Service Bulletin

Control column wheel and aileron cable operating arm shaft inspection.

Issue 2 – Serial number applicability amended. Section 3 amended to replace existing steel shafts with bronze items.

Document: Service Bulletin SB-GA8-2004-11

Figure 3

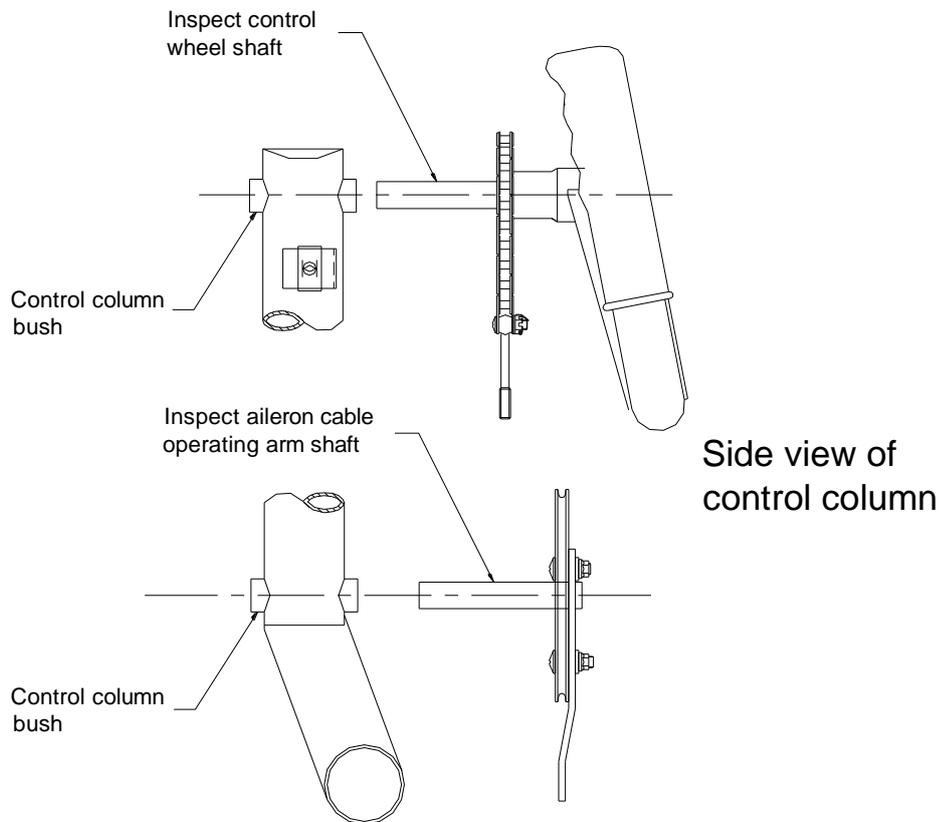
4. Disconnect the aileron cable-operating arm assembly from the aileron link plate (single control installation) or aileron link rod (dual control installation).
5. Remove the control wheel assembly and aileron cable-operating arm assembly from the control column.
6. Inspect the control wheel and aileron cable operating arm shafts for evidence of wear due to galling between the shaft and the control column bush. Refer to Figure 3.

7. If there is no evidence of wear then the shaft is serviceable and no further action is required. Re-install per section 4.
8. If there is evidence of light marking on the shaft as indicated by general even wear adjacent to the weldment then the shaft and the control column bush can be reworked (refer to section 2) or replaced with new bronze items (refer to section 3).
9. If there is evidence of significant marking on the shaft as indicated by scratches, scoring or galling then the shaft must be replaced and the control column bush reworked. Refer to section 3.

Figure 4

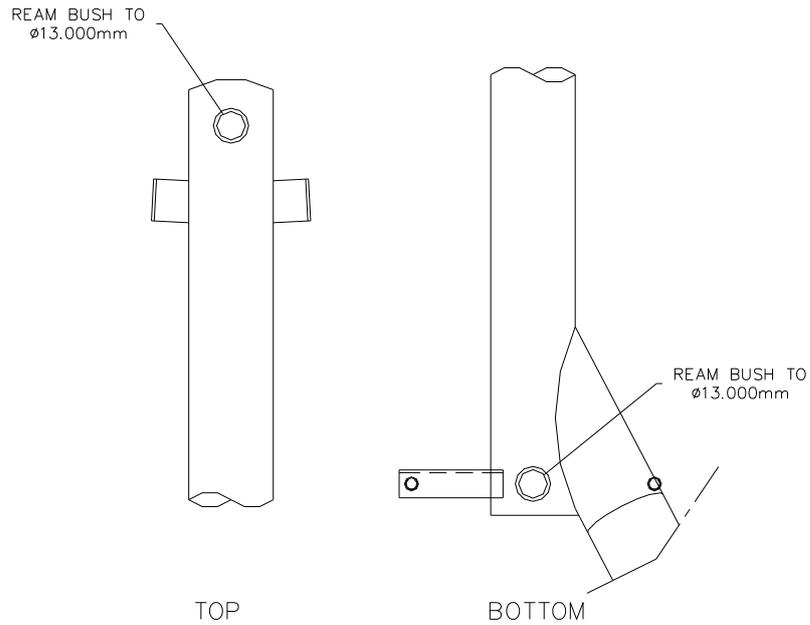
2. Remove the control column assembly from the aircraft.
3. Remove the control wheel assembly and aileron cable operating arm assembly from the control column. Discard the aileron cable operating arm assembly.
4. Remove the existing control wheel shaft from the control column and discard.
5. Using a H7 fit 13mm reamer, ream out the existing upper and lower control column bushes. Refer to Figure 4. It is important that this size reamer be used as the bronze shafts supplied have been machined to a normal running fit based on a 13mm bore size.

Figure 5

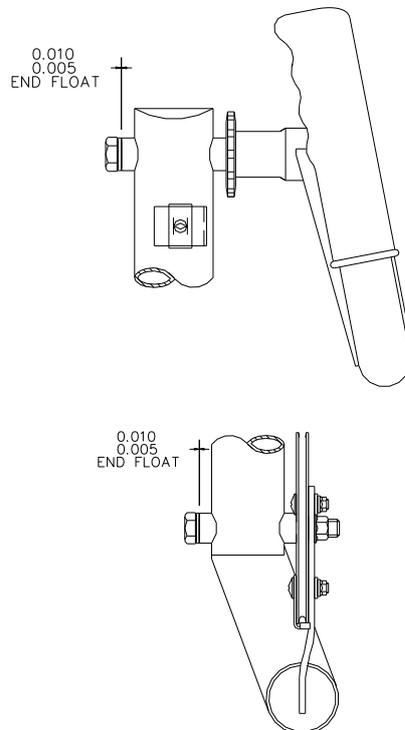
6. The bronze shafts have also been machined slightly over length to account for manufacturing variations in the length of control column bushes between individual aircraft. The required end float of the completed assemblies is 0.005" - 0.010". Refer to Figure 5. Material can be removed from the bronze shaft if the clearance exceeds 0.010", or by grinding back the control column bush if the clearance is less than the 0.005" minimum.

Figure 6a

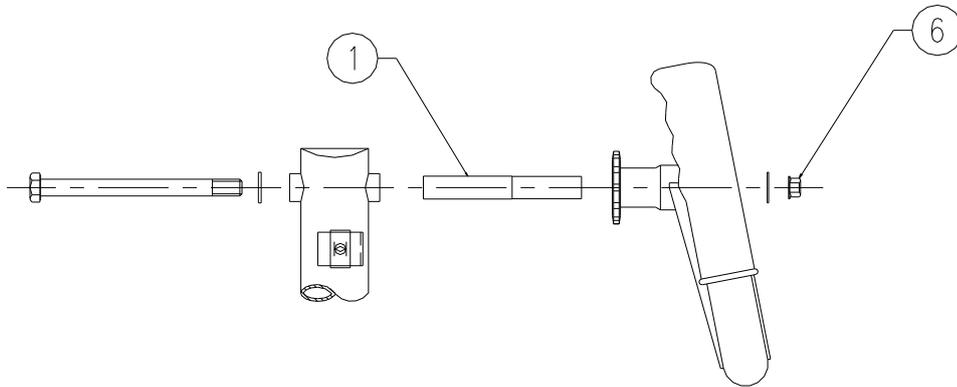
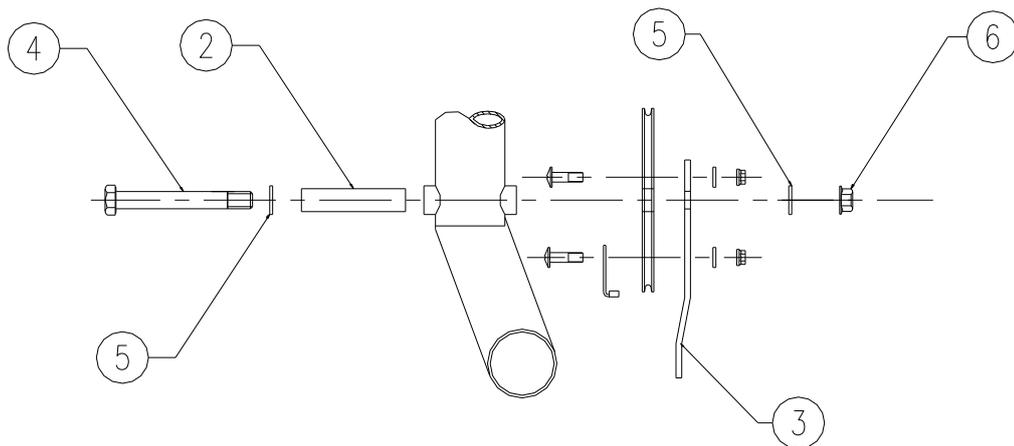
7. Ream the central hole of the aileron operating arm wheel (P/N GA8-273023-31) to 13mm to accommodate the increased diameter of the bronze shaft.
8. Assemble the control column using the items per Figure 6a and 6b. Ensure that the minor diameter of item 1 is inserted into the control wheel housing. Apply a general-purpose grease or an anti seize compound such as Loctite Silver Grade or Bostik Never-Seez to the shafts prior to installation into the control column bushes. Torque the nuts to 160 – 190 in.lbs. Parts not ballooned are existing items that can be re-used.
